Access Compliance Report

Public Rights-of-Way

(Curb Ramps)

Intersection ID: 53349	Main Street: SAPPHIRE_HILL_LN	Cross Street: N/A	Location: SW
ADA ID: F4D9386EBFE1	Ramp Type: Perp	Initial Pass/Fail: Pass	Overall Compliance: No
Codes/Mitigation Info/Possible Solution		Field Measurements/Component Compliance	
Severity Score: 5

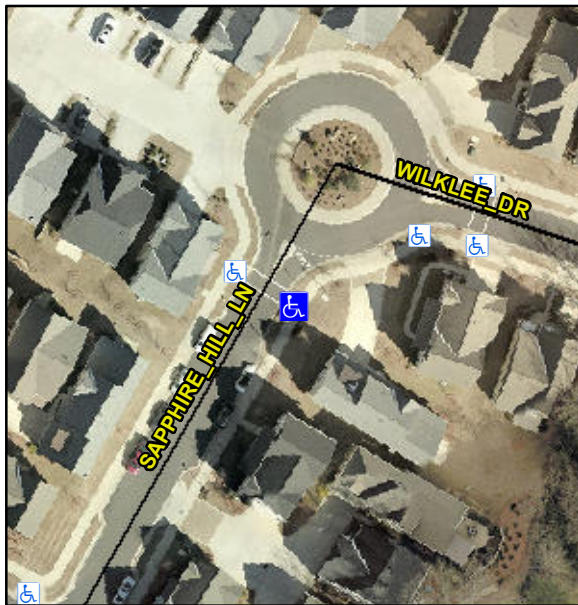
**Remove & Replace Entire Ramp.
Gutter Ponding Observed.**

**R304.2.2-Perp, R304.3.2-Para,
R304.5.3, R304.2.3, R302.7**

Compliance	Description	Data	Compliance	Description	Data
N/A	Ramp Length (in)	59.5	Yes	Ramp Slope (%)	7.9
Yes	Ramp Width (in)	48.0	Yes	Ramp XSlope (%)	0.1
N/A	Flare Type LT	Sloped	N/A	Flare Type RT	N/A
N/A	Flare Slope LT (%)	10.4	No	Flare Slope RT (%)	12.5
N/A	Flare Traversable LT?	Yes	N/A	Flare Traversable RT?	Yes
Yes	Landing Length (in)	71.5	Yes	DWS Provided?	Yes
Yes	Landing Width (in)	48.0	Yes	DWS Contrast?	Yes
No	Landing Slope (%)	2.2	Yes	DWS Length (in)	24.0
No	Landing X Slope (%)	3.1	Yes	DWS Full Width?	Yes
N/A	Landing Curb? (Y/N)	No	Yes	DWS Offset (in)	2.0
N/A	Shared Landing?	No			
No	Gutter Ponding?	Yes	Yes	Gutter Slope (%)	1.8
Yes	Gutter Lip Ht (in)	0.0	Yes	Gutter X Slope (%)	1.8
N/A	Painted X Walk1?	Yes	N/A	Painted X Walk2?	N/A
	X Walk 1 Direction	To NW		X Walk 2 Direction	N/A
N/A	X Walk 1 Width (in)	87.5	N/A	X Walk 2 Width (in)	N/A
	X Walk 1 Slope (%)	2.9		X Walk 2 Slope (%)	N/A
	X Walk 1 X Slope (%)	1.8		X Walk 2 X Slope (%)	N/A
